## AIRWORTHINESS DIRECTIVE

No. 2020-FATA-01020A-03

Applicability – RRJ-95 aircraft

### **TECHNICAL DECISION RRJ0000-OR-470-4159**

Operational Test of the Damper of the Emergency Power Assist System of the Forward (Aft) Entry Door  
Figure 501

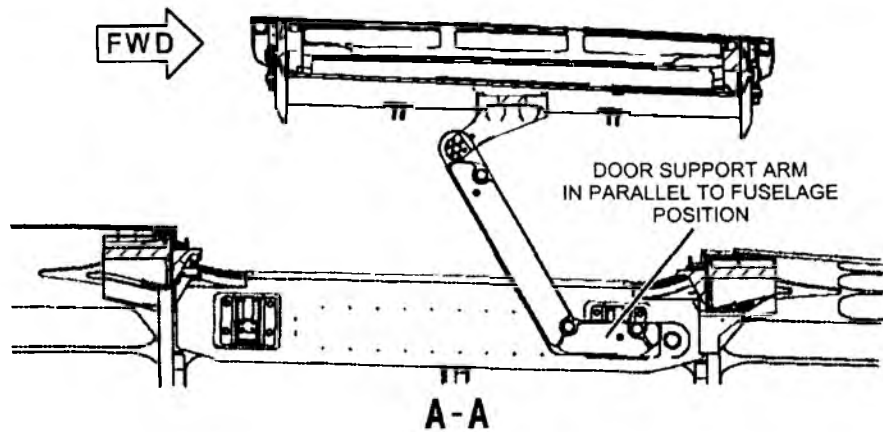
- (1) Open the forward (aft) entry door from the inside (*Ref. Task 52-10-00-010-801, Steps 4A(1)–4A(5)*).
- (2) Move the forward (aft) entry door forward suddenly for a maximum of 1 s to release it from the fuselage. Before the support arm (*Ref. Fig. 501*) is parallel to the fuselage, make sure that the door speed decreases and the force for its movement suddenly increases.
- (3) Pull the forward (aft) entry door at the internal handle and bring it closer to the door frame.
- (4) Do the Steps (2) and (3) again five times.

Operational Test of the Damper of the Emergency Power Assist System of the Forward (Aft) Service Door  
Figure 501

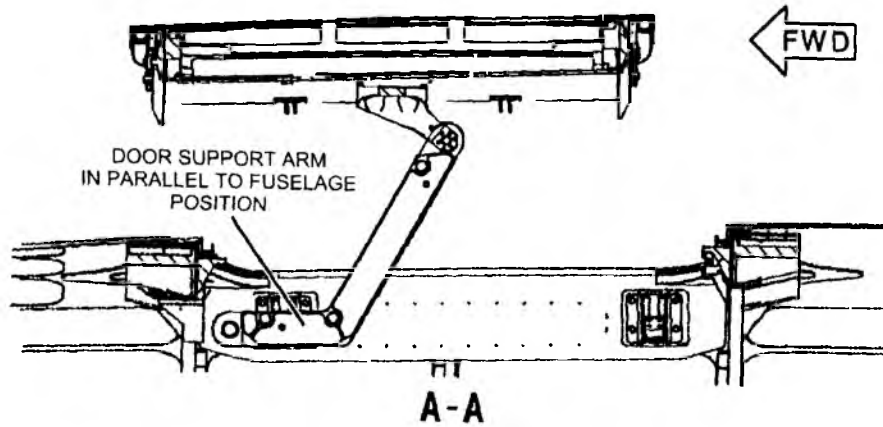
- (1) Open the forward (aft) service door from the inside (**Ref. Task 52-10-00-010-801, Steps 4A(1)–4A(5)**).
- (2) Move the forward (aft) service door forward suddenly for a maximum of 1 s to release it from the fuselage. Before the support arm (**Ref. Fig. 501**) is parallel to the fuselage, make sure that the door speed decreases and the force for its movement suddenly increases.
- (3) Pull the forward (aft) service door at the internal handle and bring it closer to the door frame.
- (4) Do the Steps (2) and (3) again five times.

Figure 1 – The correct position of the apron of the slide

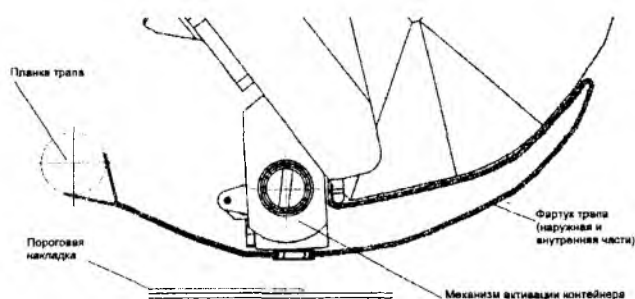
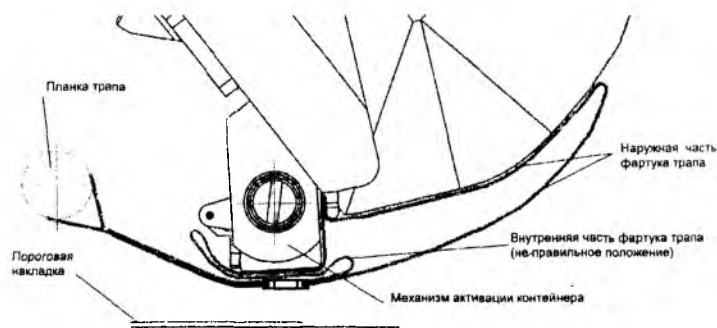
6. Make sure that the inside of the apron of the slide is in the right position, as shown in Figure 1. In the case of the wrong position of the apron (Figure 2) lay it according to Figure 1:

Figure 3 – The correct position of connector

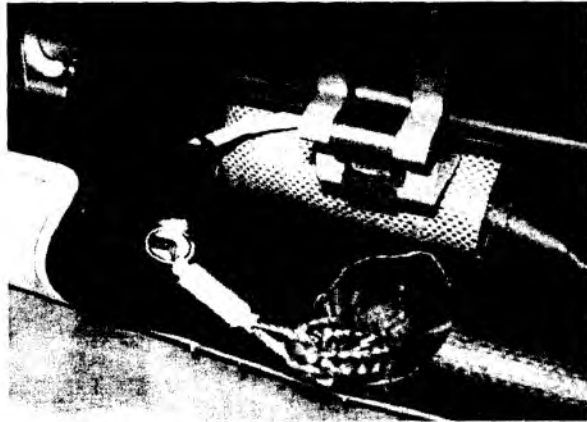
8. Control the position of the quick-disconnect connector. Make sure the connector of the quick-disconnect is placed closer to the board away from the opening mechanism, as shown in Figure 3:
